# HISTORIC AND DESIGN REVIEW COMMISSION

June 01, 2022

**HDRC CASE NO:** 2022-309  
**ADDRESS:** 501 QUITMAN ST  
**LEGAL DESCRIPTION:** NCB 992 BLK 1 LOT S 120 FT OF MID 40 FT OF B  
**ZONING:** R-6, H  
**CITY COUNCIL DIST.:** 2  
**DISTRICT:** Government Hill Historic District  
**APPLICANT:** Melody Patrick/FDN Home, LLC DBA Forty Degrees North  
**OWNER:** BEXAR TEXAS REAL PROPERTY TRUST TWO  
**TYPE OF WORK:** Construction of a rear addition, rehabilitation, repair and maintenance, roof replacement  
**APPLICATION RECEIVED:** May 13, 2022  
**60-DAY REVIEW:** Not applicable due to City Council Emergency Orders  
**CASE MANAGER:** Edward Hall

West Elevation

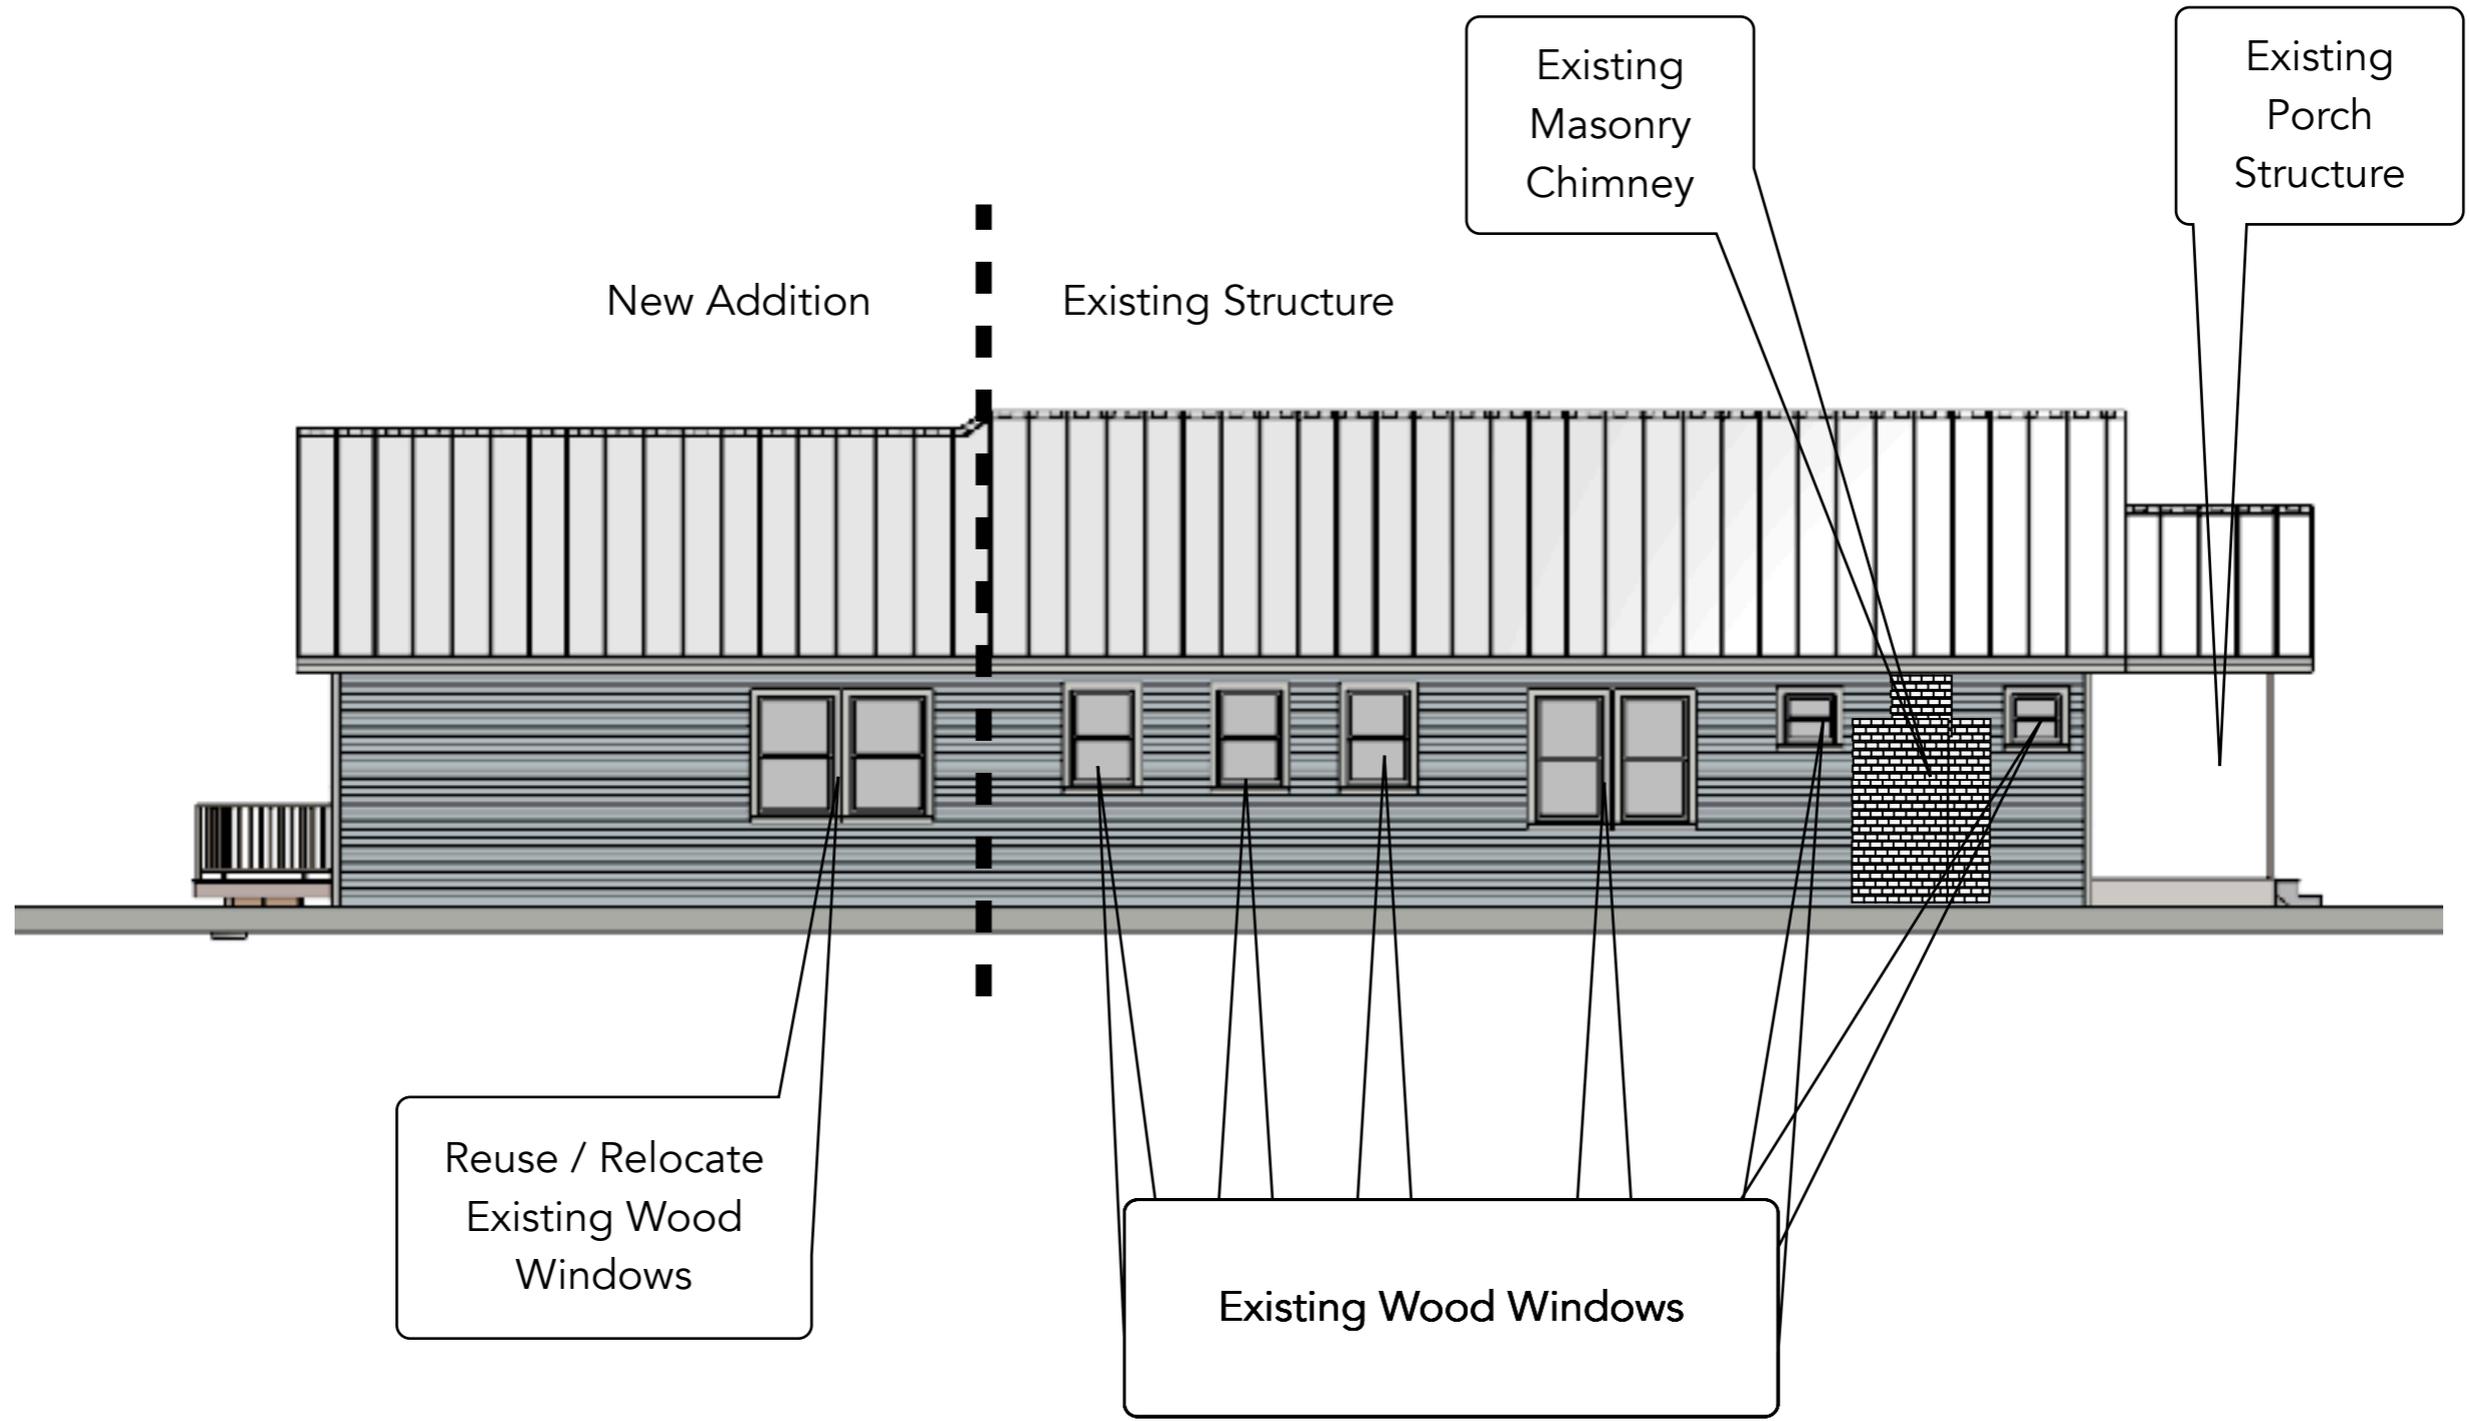
block, should feature similar roof forms, and should feature a transition to differentiate the new addition from the historic structure. Additionally, the Guidelines for Additions 1.B notes that additions should be subordinate to the principal façade of the historic structure, should feature a footprint that responds to the size of the lot, should not double the existing building footprint, and should feature an overall height that is generally consistent with that of the historic structure. Generally, staff finds the proposed addition to be appropriate and consistent with the Guidelines; however, staff finds that a vertical trim piece should be added to the west elevation to differentiate the addition from the primary historic structure.

- 7. Staff recommend approval of items #7, the construction of a rear addition based on findings i through m with the following stipulations:
  - i. That a vertical trim piece be installed on the west façade to differentiate the addition from the primary historic structure.
  - ii. That the roof feature panels that are 18 to 21 inches wide, seams that are 1 to 2 inches in height, a crimped ridge seam and a standard galvalume finish. Panels should be smooth and not feature corrugation or striations. A ridge cap with no end cap or a ridge sleeve should be submitted to OHP staff for review and approval.
